PLANNING, ZONING, & BUILDING DEPARTMENT
PZ&B Staff Memorandum: Architectural Commission (ARCOM)

SUBJECT: ARC-22-243 (ZON-23-014) 302 SEABREEZE AVE

MEETING: MAY 24, 2023

ARC-22-243 (ZON-23-014) 302 SEABREEZE AVE (COMBO): The applicant, Sean Rooney, has filed an application requesting Architectural Commission review and approval for the construction of a new two story single-family residence with related landscape and hardscape improvements, requiring Site Plan Review due to deficient lot width and area, and variances to provide one garage parking space in lieu of the two required and to install air conditioning condensing units and a generator in the rear yard setback without being completely screened from the adjacent property. This is a combination project that shall also be reviewed by Town Council as it pertains to zoning relief/approval.

EXIST. REAR SITE WALL VARIANCE @ GENERATOR

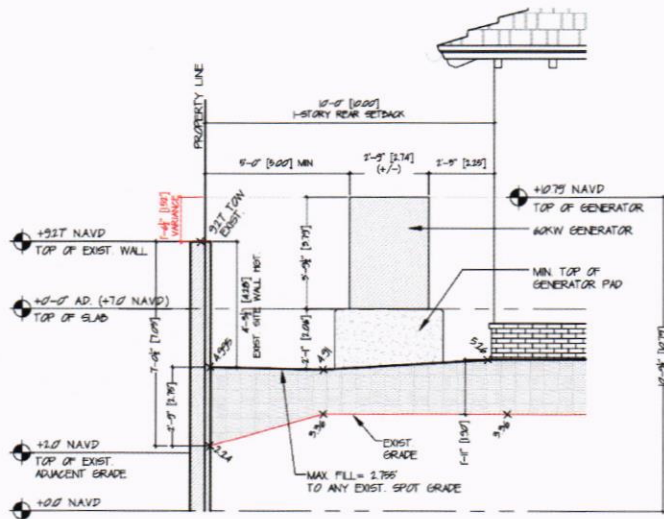
Code Section	Required	Proposed	Variance
Sec. 134-1729(1)(d)	Generator to be completely screened from neighboring property with a masonry wall	Partially screened by existing masonry wall	1' -6 1/2" Unscreened

The site plan for the property locates the mechanical equipment in the east (side) and south (rear) yards. The mechanical equipment within the east yard is located either outside of the required side yard setbacks or is screened with code compliant masonry walls. The rear equipment yard adjacent to the south wall of the garage contains a 60kW generator unit within a yard setback. The generator is required to be screened from adjacent properties with a masonry wall as high as the equipment.

A masonry site wall that is proposed to remain on the rear property line measures 7'-0 1/2" in height when measured from the neighboring grade, already exceeding the 7' maximum wall height allowed by Code. As mechanical equipment is required to be placed at 7' NAVD, the generator exceeds the height of the existing wall. Sheet SP-3 of the architectural plans provides a variance diagram depicting the request.
